TRUCK, CARGO, WITH CRANE, HEAVY, MC3 (MACK)  
EXHAUST TAIL PIPE

MODIFICATION INSTRUCTION

Reference: A. EMEI VEHICLE G 799-1

FIG 1 - STRAIGHT EXHAUST TAIL PIPE

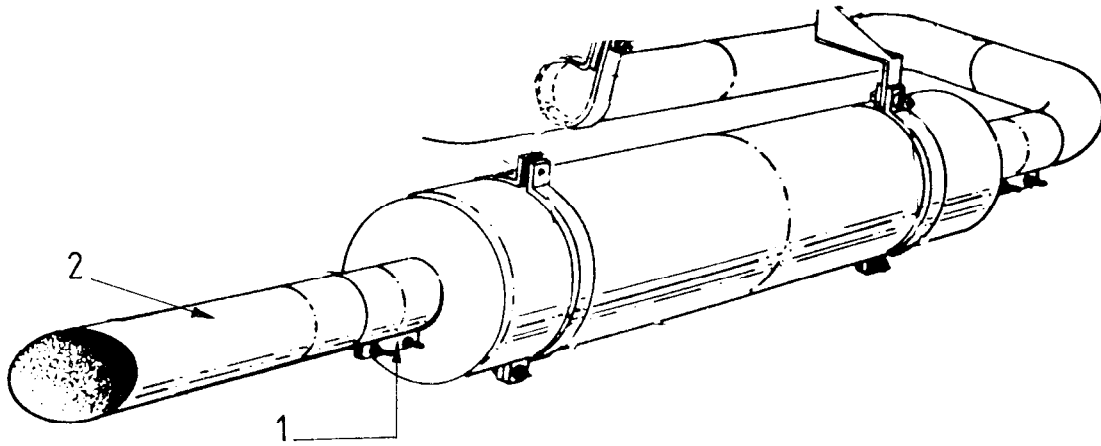
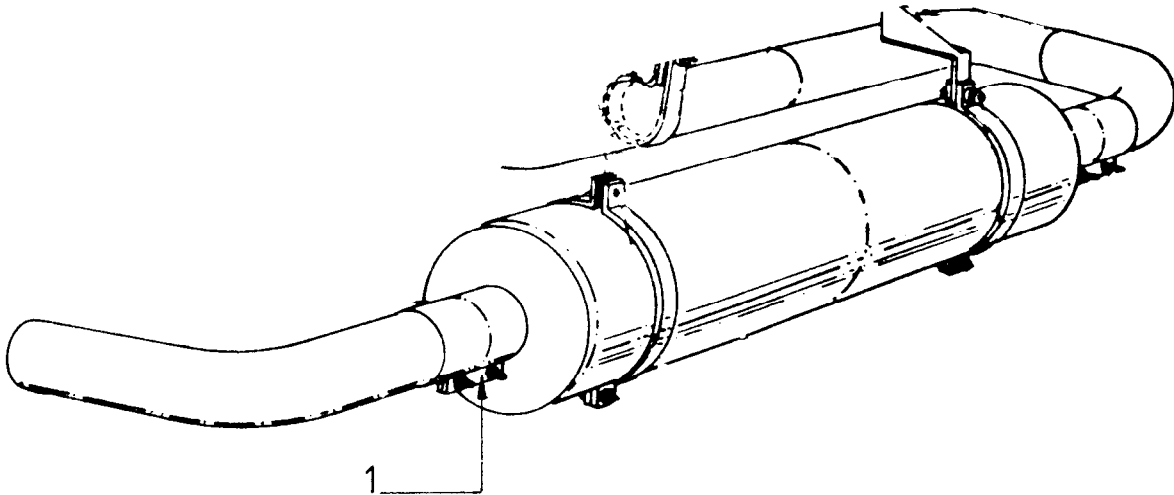
1. This EMEI replaces VEHICLE G 717-2 Issue 1 which is to be destroyed.
2. This instruction details the replacement of the straight exhaust tail pipe with a curved type to deflect exhaust emissions rearward and eliminate the discomfort being caused to other road users.

8. To carry out the modification, proceed as follows:
  - a. Loosen the clamp, item 1 in Fig 1 and remove the exhaust tail pipe, item 2.
  - b. Using the original clamp, item 1 in Figs 1 and 2, fit the new exhaust tail pipe, item 1 Table 1 as shown in Fig 2. Ensure the tail pipe is facing rearward and slightly downward and tighten the clamp.
